**HISTORIC PRESERVATION BOARD STAFF REPORT**

**Sundy Village – Block 61 Landscape**

Meeting	File No.	Application Type
May 1, 2024	2024-093	Level 1 Site Plan and Certificate of Appropriateness

The item before the Board is consideration of a Level 1 Site Plan and Certificate of Appropriateness (2024-093) request for landscape and hardscape modifications to the **Block 61 portion of the Sundy Village project, Old School Square Historic District.**

**J** WATER FEATURE  
 SCALE: 1/8" = 1'-0"

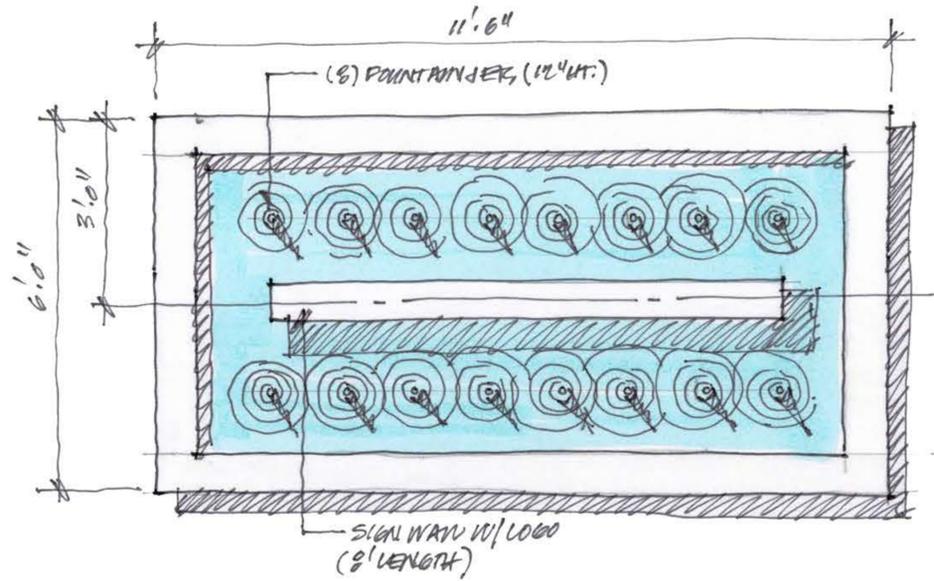
The subject proposal consists of modifications to the existing/approved landscape plan and fountain/water feature for Block 61 of the Sundy Village project. With regard to the proposed changes to the fountain/water feature, the new water feature will be a limestone/travertine material and can be considered appropriate for use on the site. It is noted that the elevations include signage which will be part of a separate application request and approval. The request does not include any modifications to any existing historic structures nor approved new construction.

1. That the fountain/water feature elevations be updated to include material details on the plans.
2. That an alternative tree species or use of multiple trees be utilized to meet the minimum mitigation requirements should the 6” caliper not be attainable. If the applicant cannot meet the 6” caliper for the proposed trees to be mitigated, then they must use an alternative tree types or multiple trees to meet the size requirement.
